SUBJECT: NuScale Power, LLC Supplemental Response to NRC Request for Additional Information No. 466 (eRAI No. 9482) on the NuScale Design Certification Application

NRC Question No.: 06.02.01.01.A-18

Conservatism in the NPM Initial Conditions for the CNV Safety Analyses

Figure 6.2-9: **Maximum Containment Internal Pressure - Peak Containment Vessel Pressure Case**

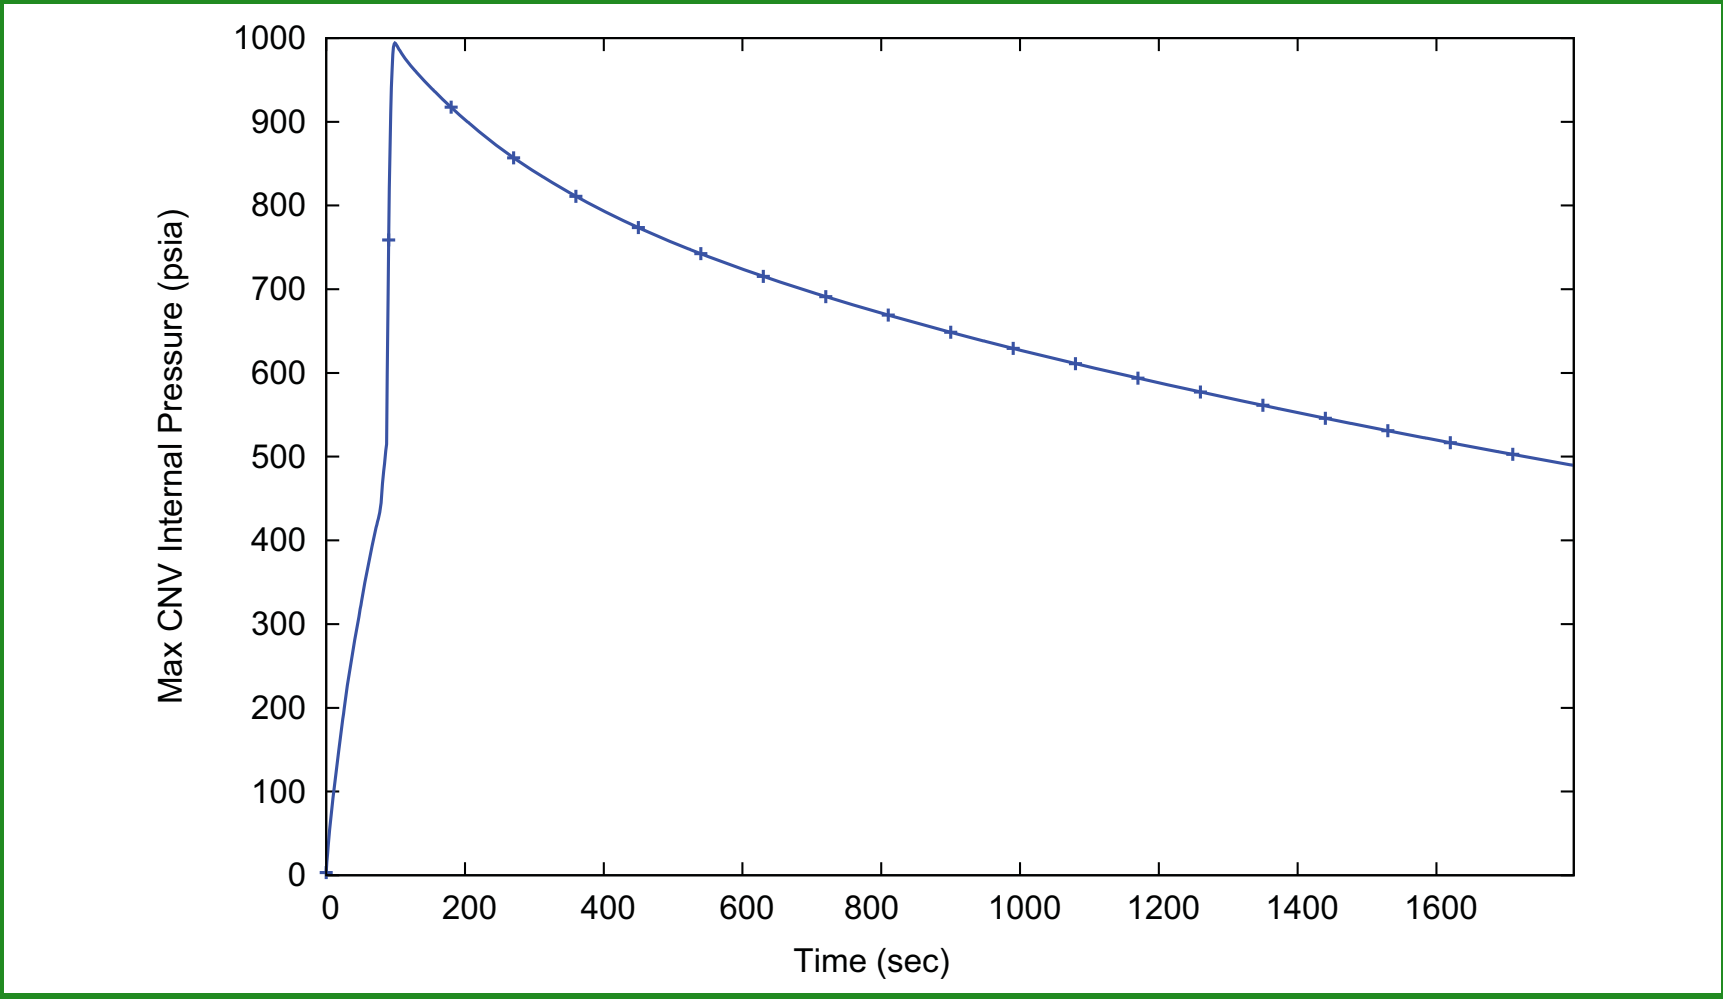
The overall limiting peak calculated containment pressure, based on the mass and energy release spectrum analyses, is postulated to occur as the result of the spurious opening of a RRV anticipated operational occurrence (Case 5). The analysis models an expansion of the RCS fluid into the CNV volume and includes all relevant energy input from RCS, secondary and fuel stored energy sources, along with conservatively modeled core power and decay heat. Additional assumptions accounting for the results of sensitivity analyses, include the loss of both the normal AC power and the highly reliable DC power system (EDSS) postulated to occur at event initiation, an IAB release pressure of 1000 psid for the second RRV, and 900 psid for the RRVs, fine CNV axial volume and fine radial CNV heat structure nodalization, fine reactor pool nodalization, fast RPV noncondensable release rate, and minimum primary system flow. ~~include the loss of normal AC power and highly reliable DC power system (EDSS) postulated to occur at event initiation and an inadvertent actuation block (IAB) release pressure of 1000 psid, fine CNV axial volume and radial CNV heat structure nodalization, fine reactor pool nodalization, RPV noncondensable release, minimum primary system flow, and single failure of one RRV to open.~~ The peak calculated pressure is ~~986~~994 psia, providing a ~~64~~56 psia margin to the CNV design pressure of 1050 psia. Reference 6.2-1, Section 5.4 discusses the analytical and design margin incorporated into the CNV design.

Figure 5-29 Case 5 containment vessel pressure - inadvertent reactor recirculation valve opening event (representative peak ~~overall limiting~~ pressure ~~case~~)

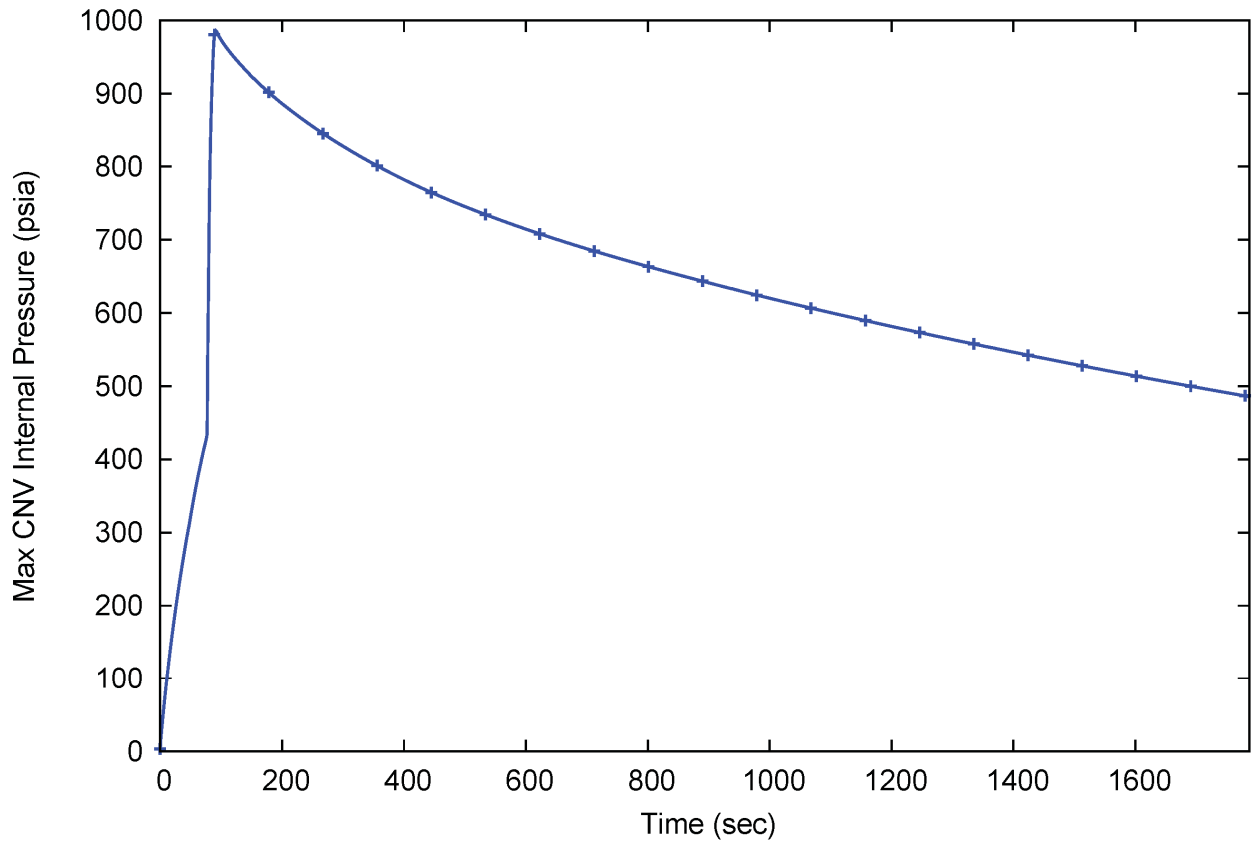
The CNV and reactor pool response for the representative Case 5 inadvertent RRV opening event~~actuation-LOCA~~ is shown in Figures 5-29 to 5-34. Figure 5-29 shows the CNV pressure response and how pressure rapidly increases to the limiting peak value of 986 psia. This limiting NRELAP5 result can be compared to the CNV design pressure of 1050 psia. ~~This is a key result of this limiting containment response analysis case.~~ Figure 5-29 also demonstrates the long term cooling capability of the UHS. CNV pressure is reduced to below 50 percent of the peak value within two hours of accident initiation.
